RIDGWAY PLANNING COMMISSION

AGENDA

STAFF REPORT

Request: Replat
Legal: Blocks 2 and 8, River Park Ridgway Business Park Planned Unit Development, Filing 1
Address: TBD Cora Street
Parcel #: 430516223067 and 430516202006
Zone: Light Industrial 1 (LI-1)
Applicant: Ridgway Light Industrial
Owners: Ridgway Light Industrial, LLC (Block 8) and Chad Baillie (Block 2)
Initiated By: Shay Coburn, Town Planner and Jen Coates, Town Manager
Date: October 30, 2018

Sheet
C1.0
ROAD & SEWER
PLAN & PROFILE

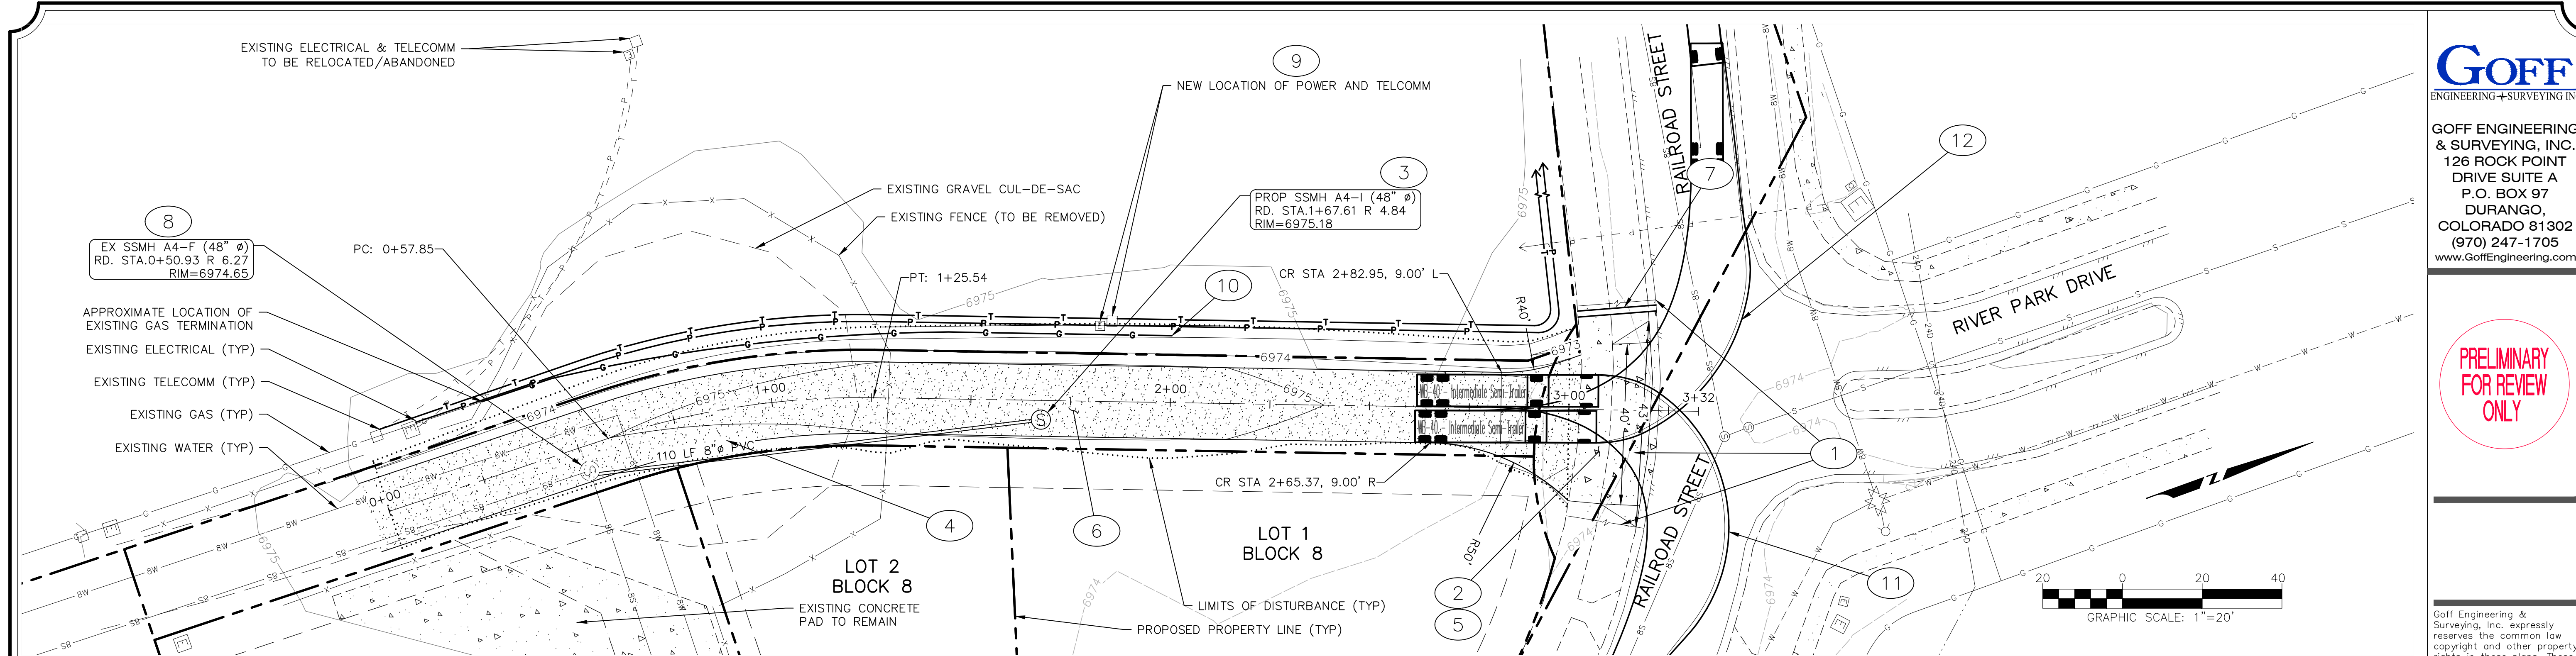
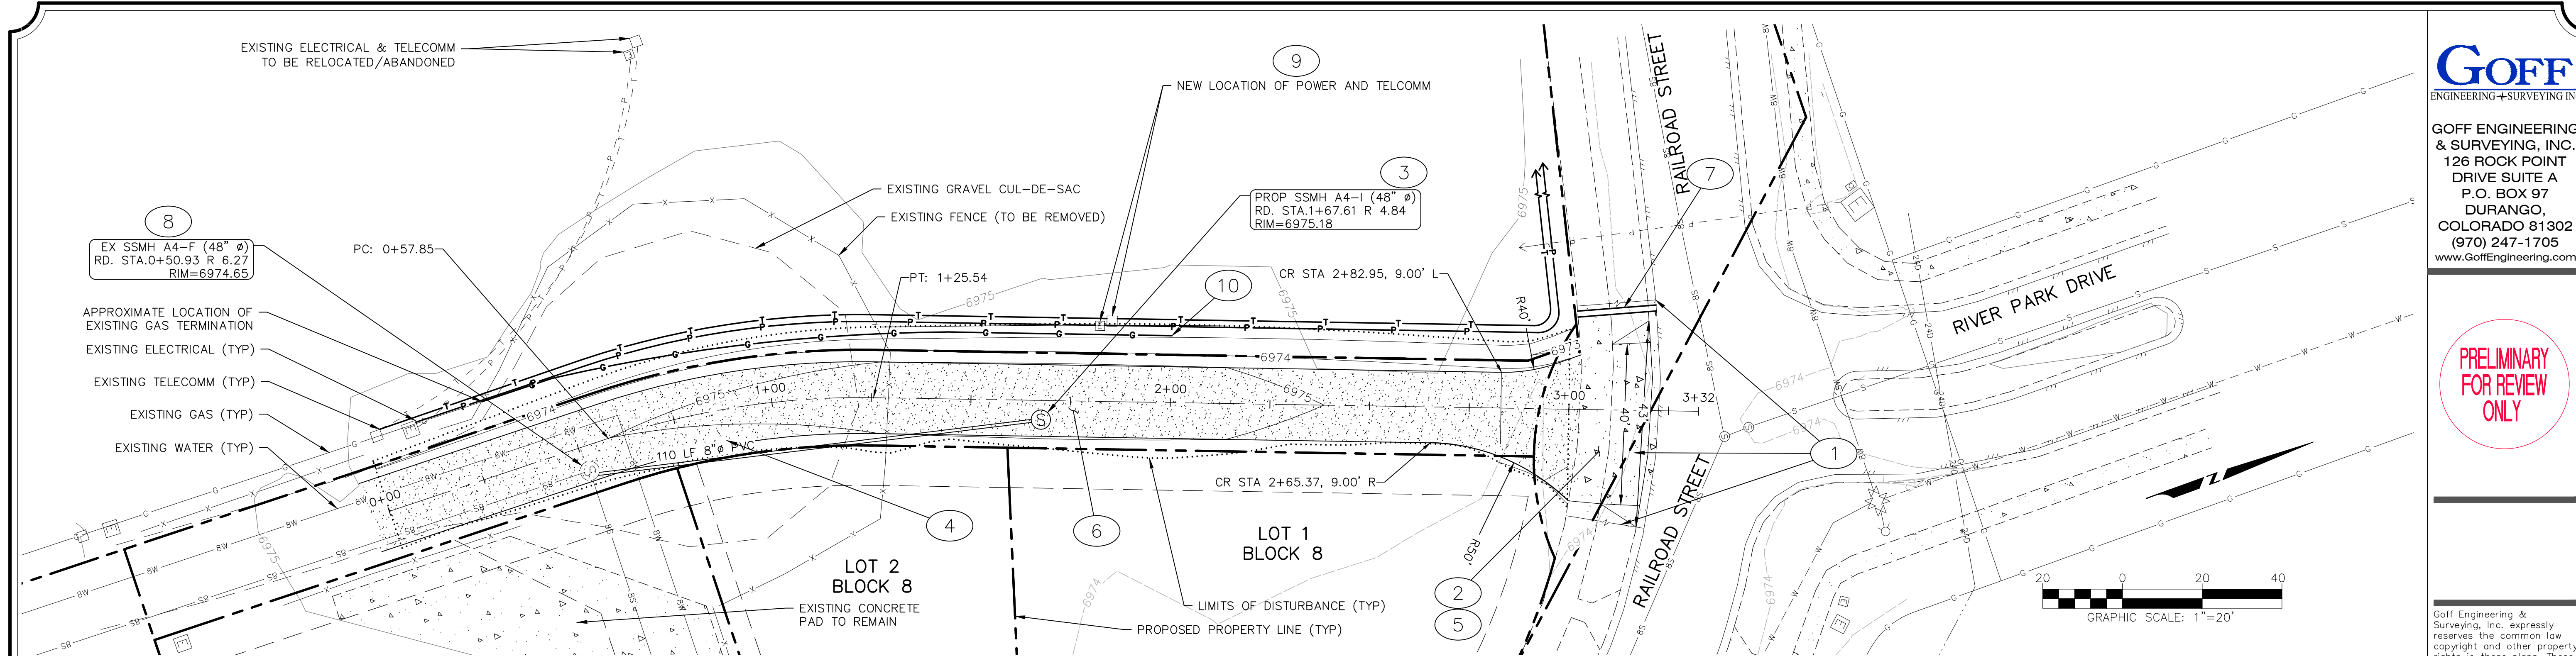
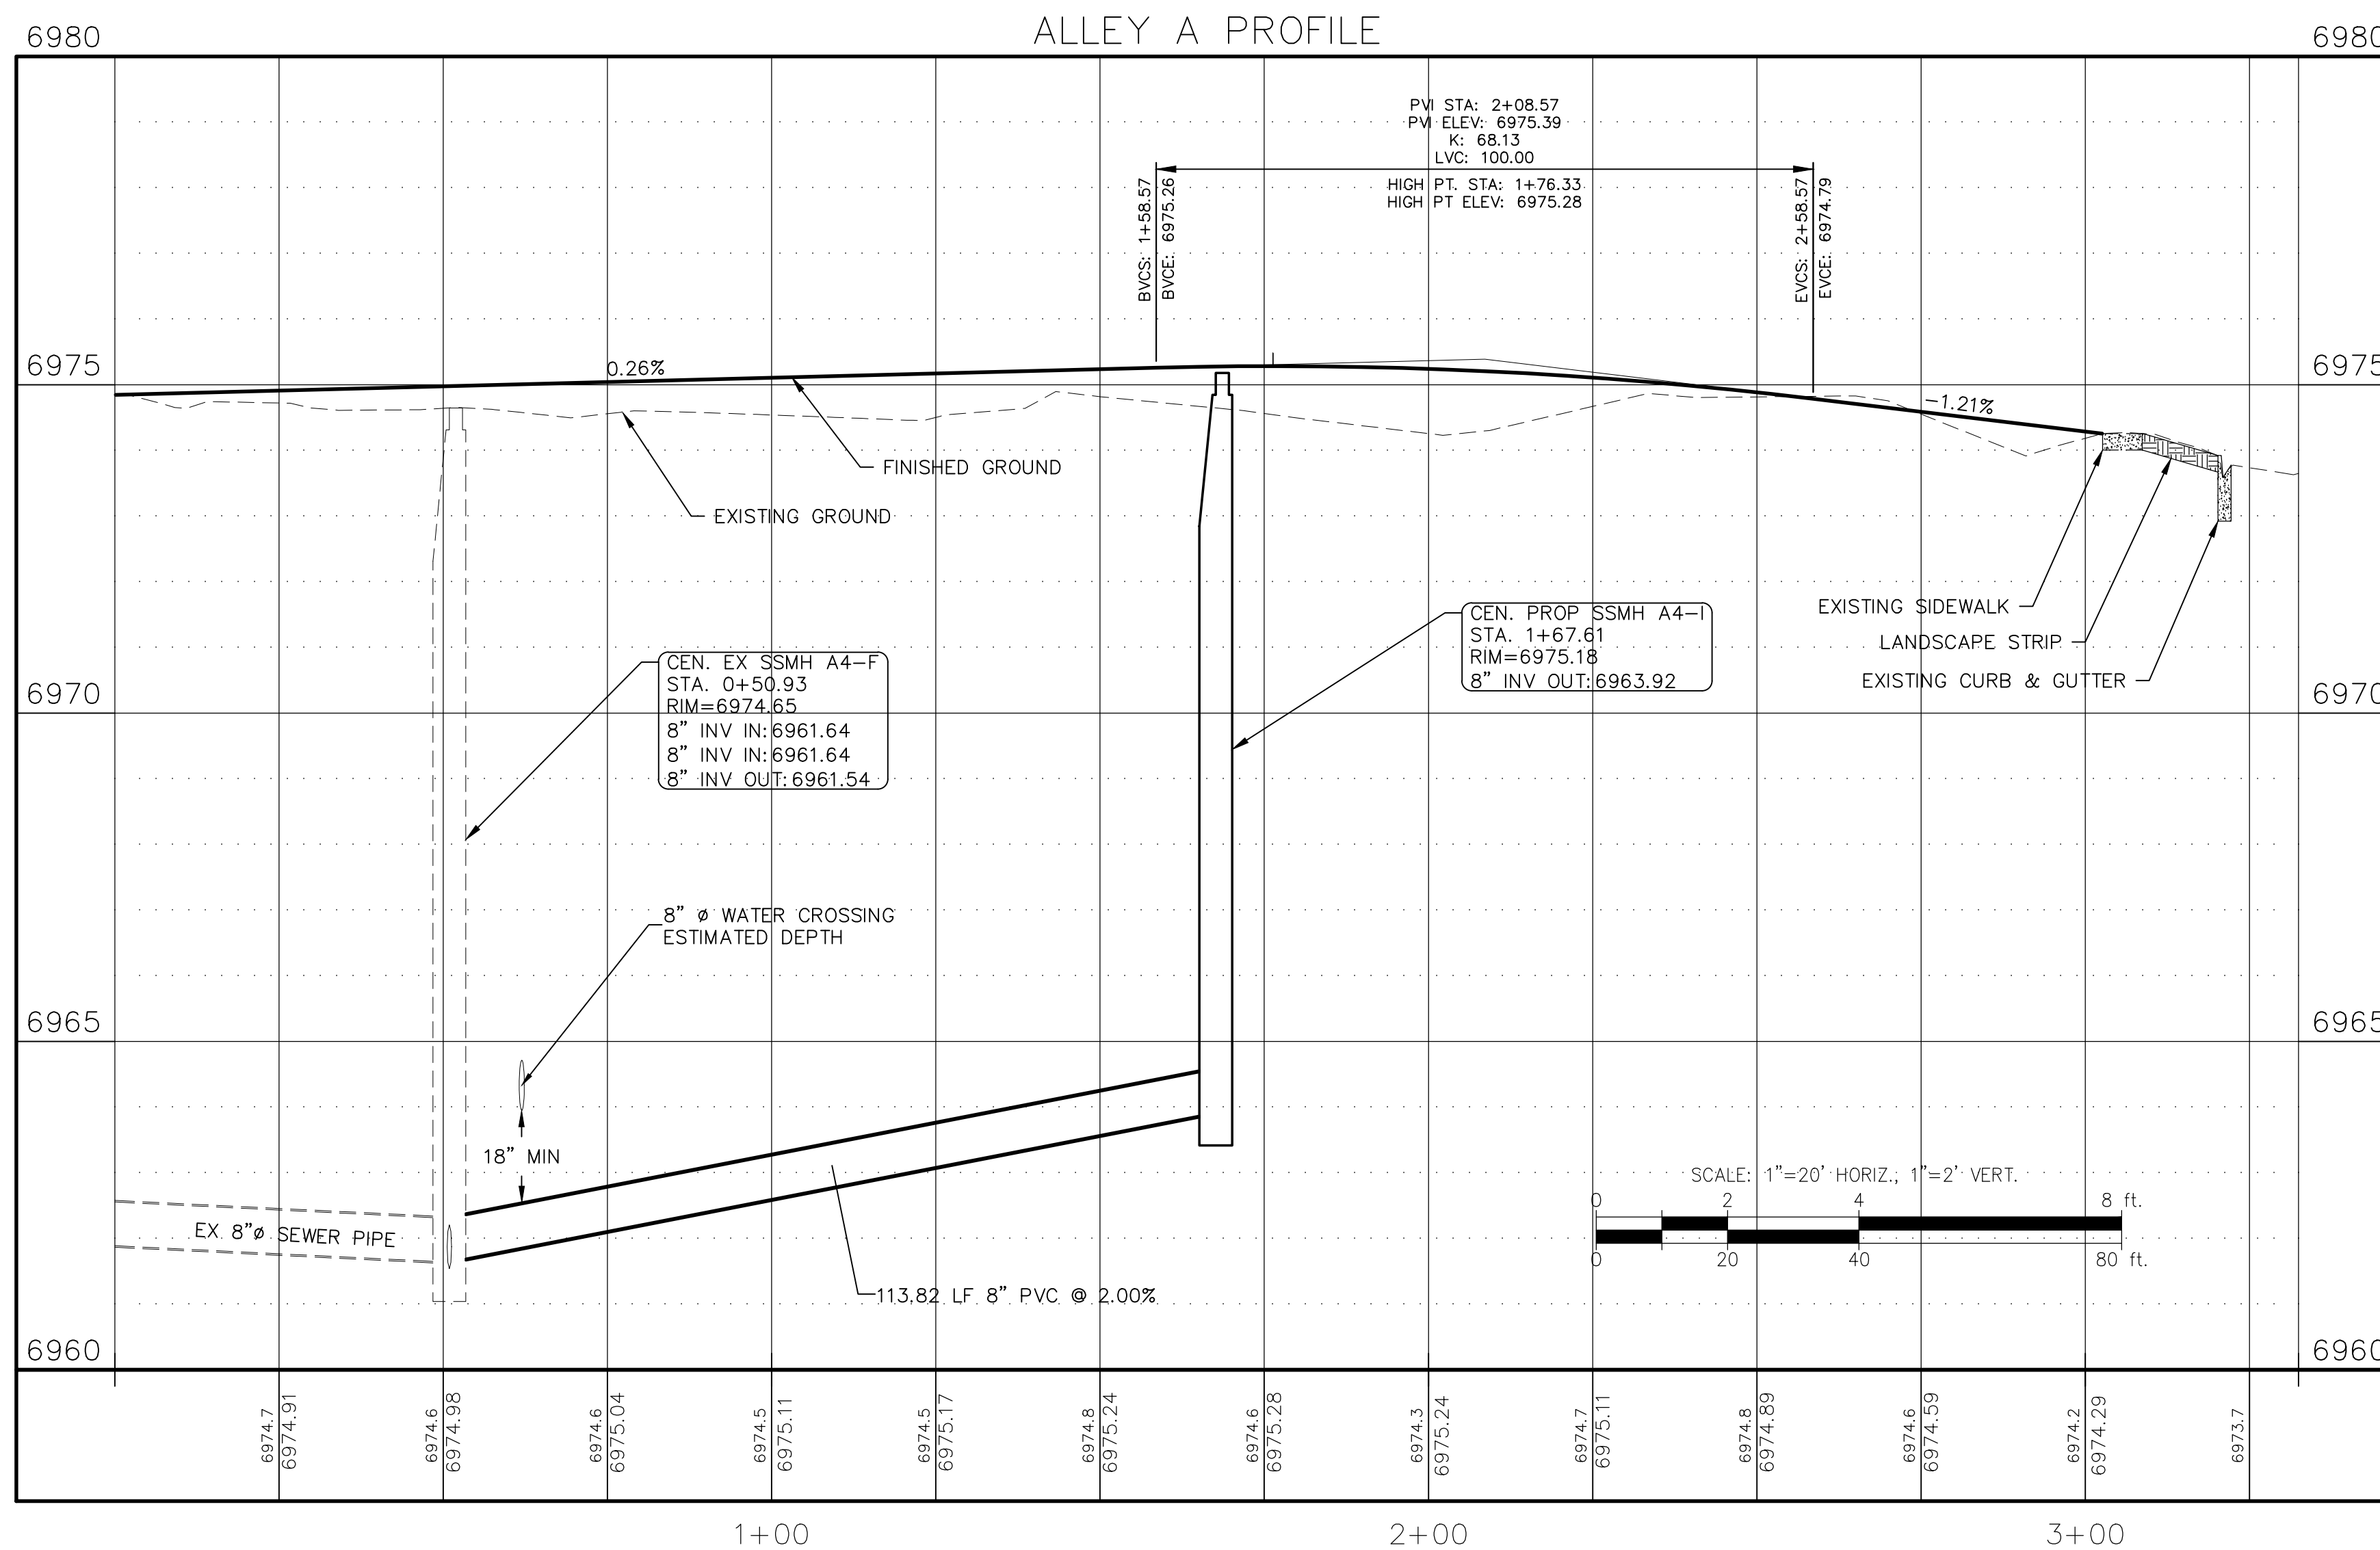
The applicant submitted plans by an engineer for the new alley and intersection. The following comments have been provided by the Town Engineer:

- The plans need to be stamped by an engineer.
- Sewer:
 - The sewer line extension appears to go just barely onto lot 2 within the proposed utility easement. This is fine but if someone wants to put a fence at their property line it may have to be taken down for repairs. It would be preferred if the sewer could move fully into the alley right-of-way.

- The arrow leader for item number 4 on the plans seems like it is pointing to the wrong thing.
 - Where will the sewer service lines be tapped into the main line?

- A few spot elevations are needed on the plan to show how the new alley will interface with the existing pavement on Railroad. The roundabout location is slightly different than what was planned in filing 1 due to the addition of the alley. It will be important to be sure this intersection is designed properly.

- Alley A Profile:
 - Show that the sidewalk, landscape strip and curb/gutter will be removed.
 - Depth of the water line should be about 5'. The drawing is showing it much deeper.

- Construction keynotes:
 - 1: add that sidewalk will be ADA accessible
